E9903G-01

Modification Recommended Service Note

Keysight i3070 Series 6 In-Circuit Test System

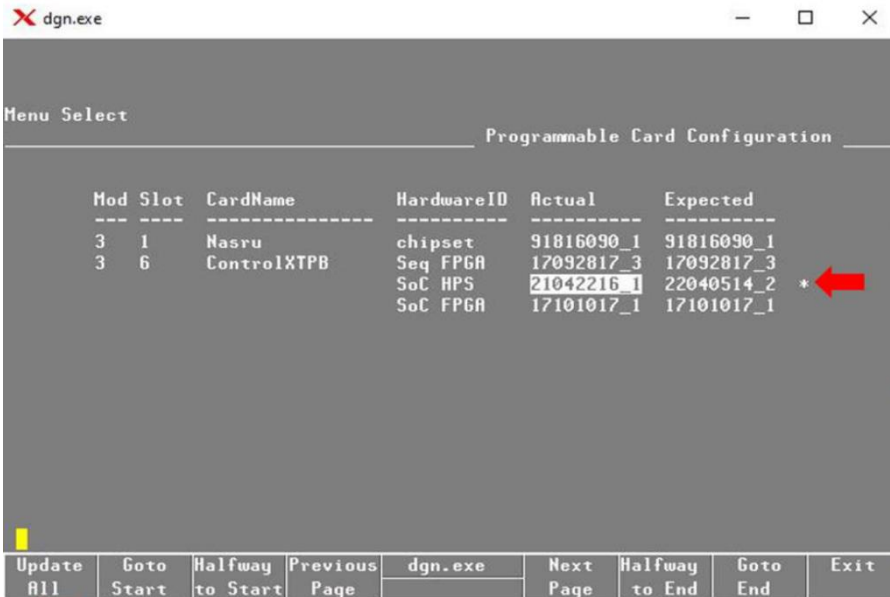
3. Launch DGN.
4. Select Configuration > Programmable Card Config.
5. Any available firmware updates will be highlighted as shown below:

6. Select “Update All” to begin the update.
7. Whenever the User Account Control dialog box appears, select “Yes” to allow the system to proceed.
8. When installation is completed, reboot the testhead.
